Subject: **FCC Class II Permission Change Request for FCC ID:ZRYBG5S**

This is to request a Class II Permission Change Request for FCC ID: ZRYBG5S, originally granted on 09/25/2017.

Figure1(Before the change)

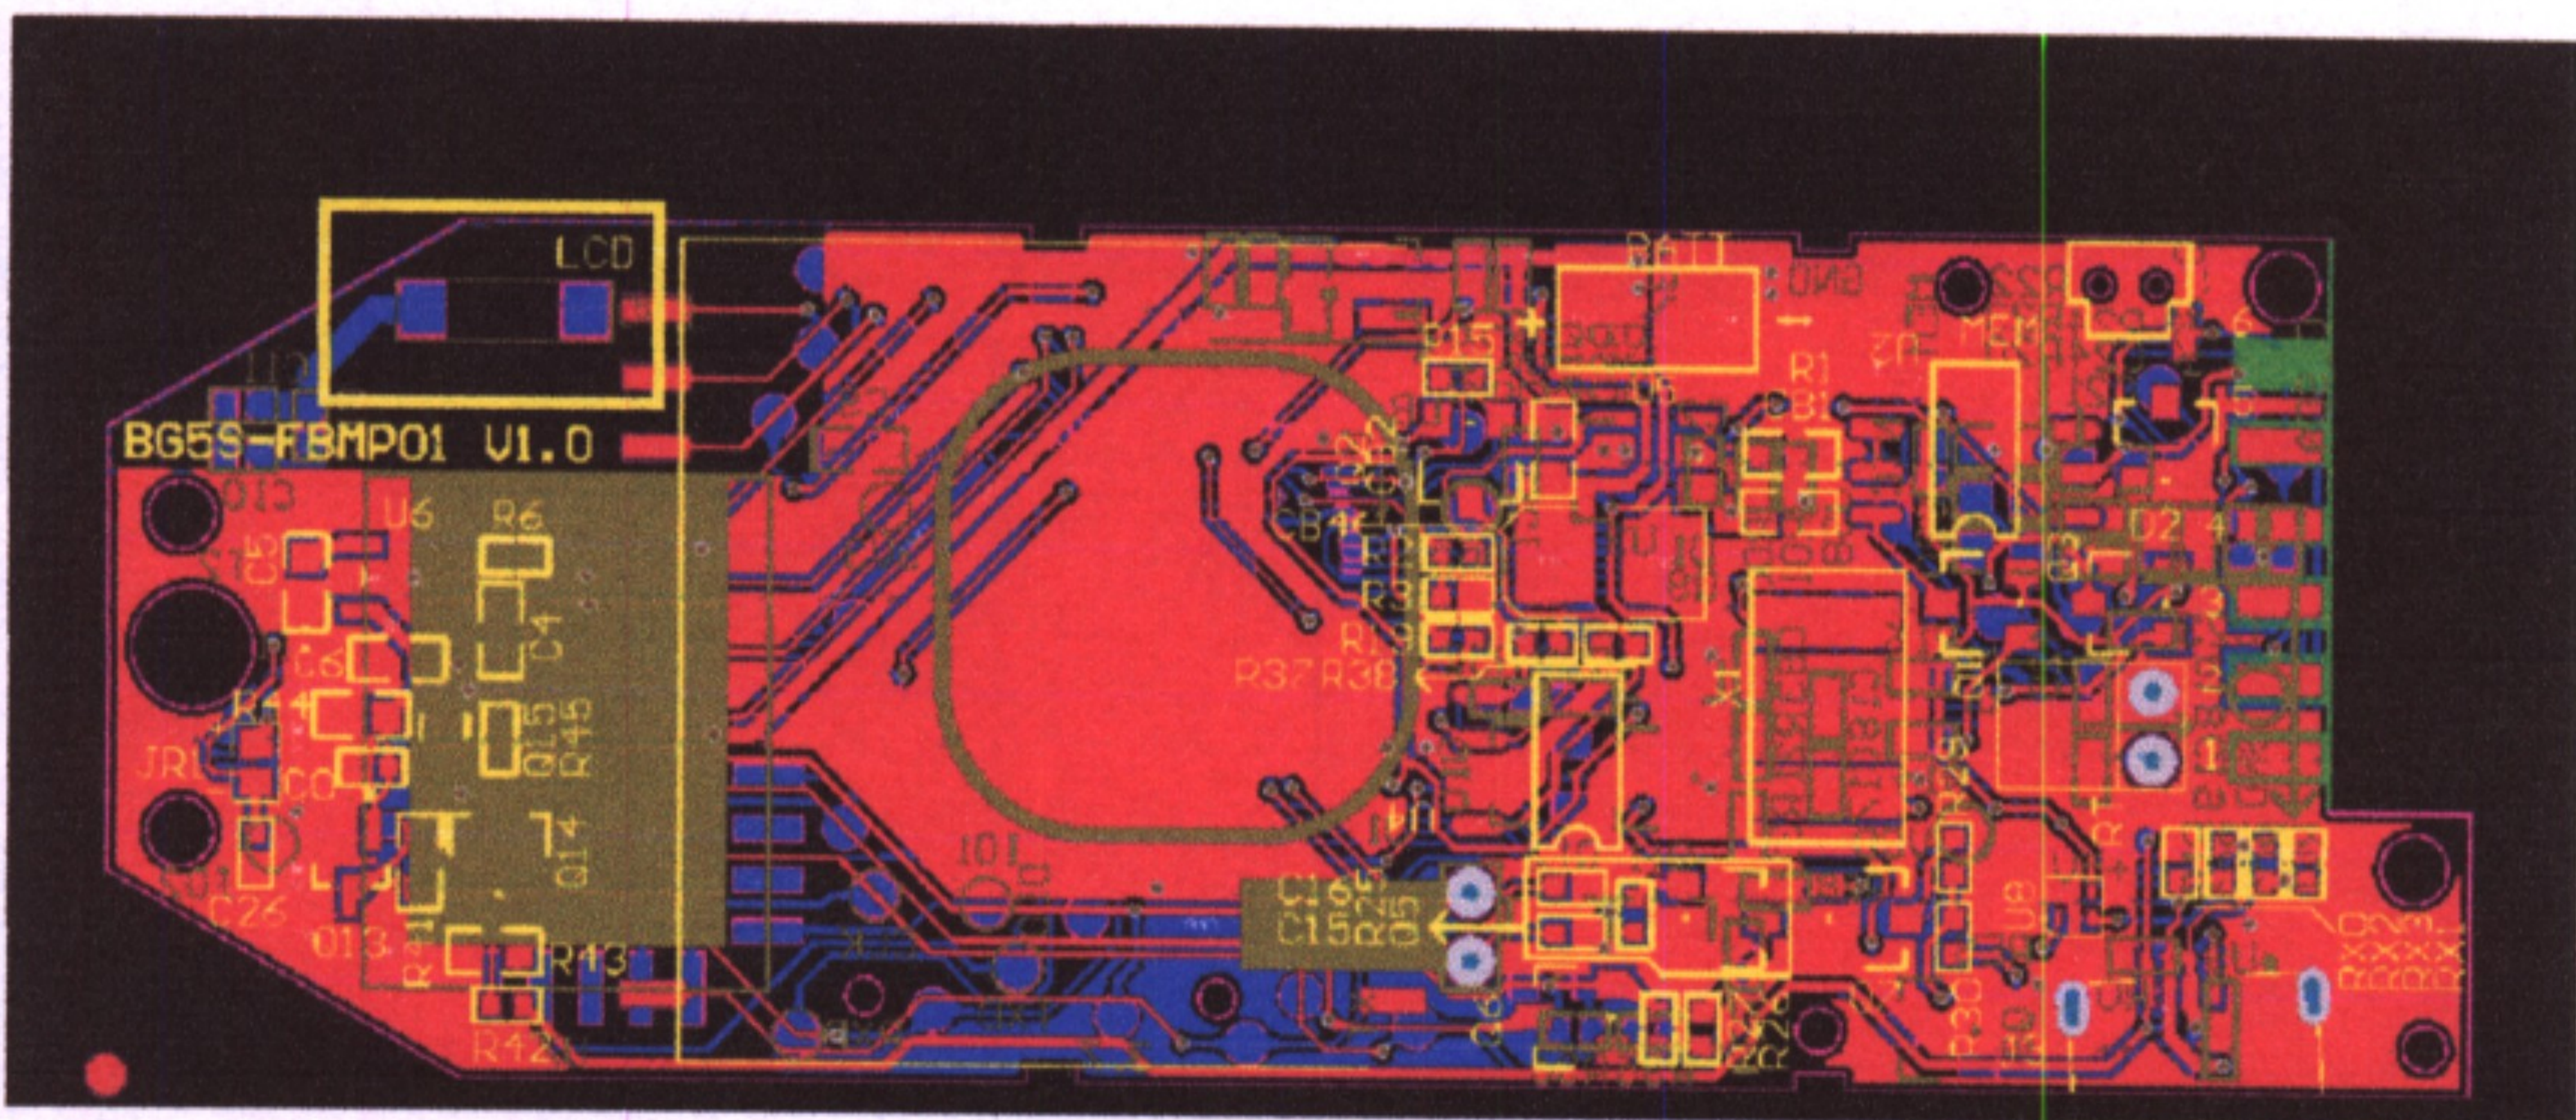
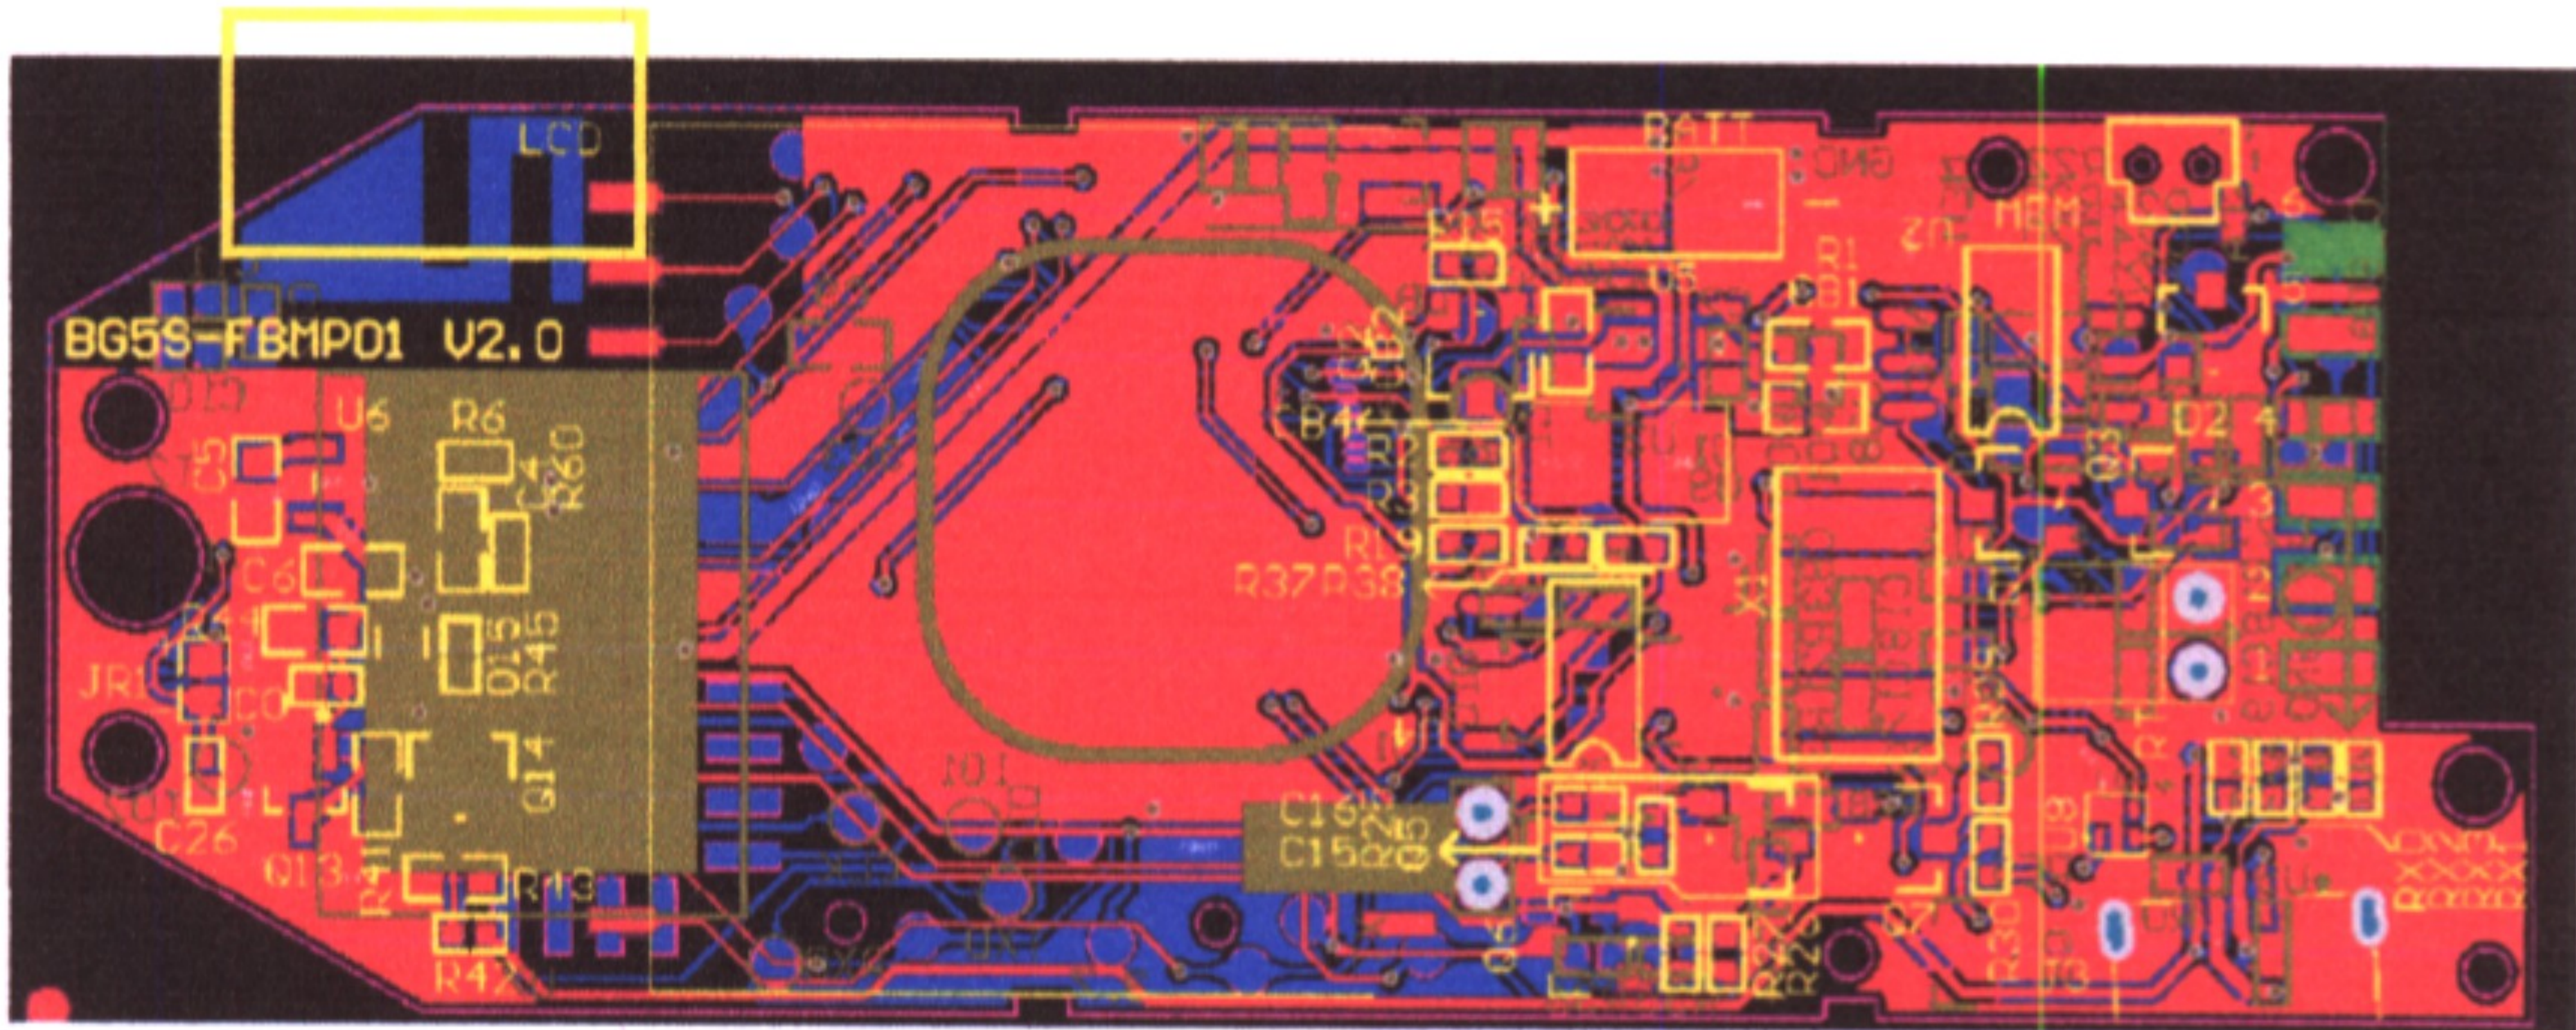
The Major change filed under this application is to change the antenna. The details are shown in the figure below. The chip antenna prototype is in the Figure 1. The yellow box in Figure 1 is the chip antenna. The PCB antenna prototype is in the Figure 2. The yellow box in Figure 2 is the PCB antenna. The gain of the chip antenna is 5dBi. The gain of the PCB antenna is 2dBi. By the way, the Figure 2 add R60, which can test the related MCU I/O working status.
